Inspection Photos

Location Name: MGP A-3 FOLLOW UP

API#: 05-071-06093

INSP. #: 695102875

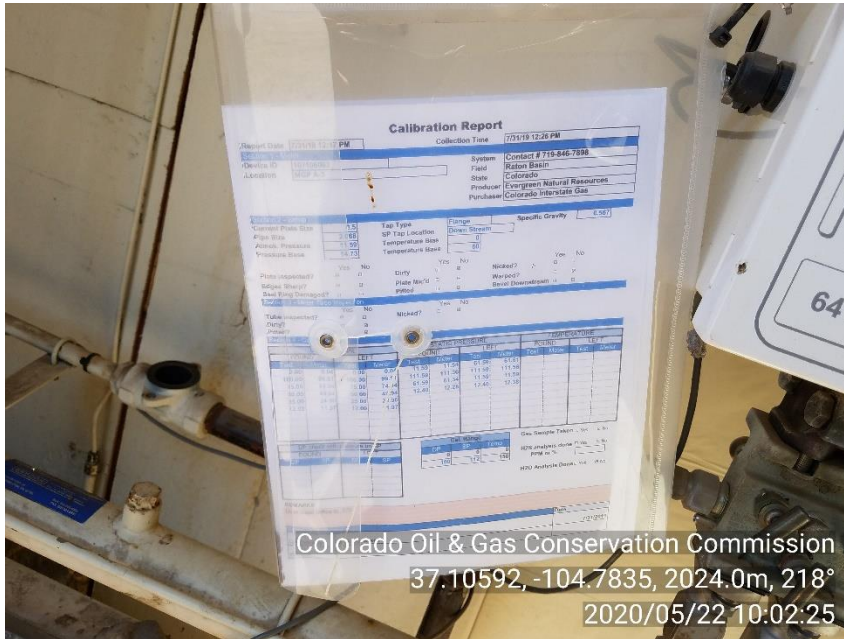
PHOTO 4: FREEBOARD MARKER IS NOT INSTALLED ACCORDING TO THE RULE (THE MARKER HAS TO BE INSTALLED ON THE LOWEST ELEVATION SIDE OF PIT MEASURED FROM ORIGINAL GROUND LEVEL, NOT THE TIP OF THE BERM). **COMPLY WITH RULE 902.b. THIS IS THE SECOND NOTICE FOR THIS CORRECTIVE ACTION, CA DATE IS THE ORIGINAL CA DATE FROM PREVIOUS INSPECTION DOC#695100198.**
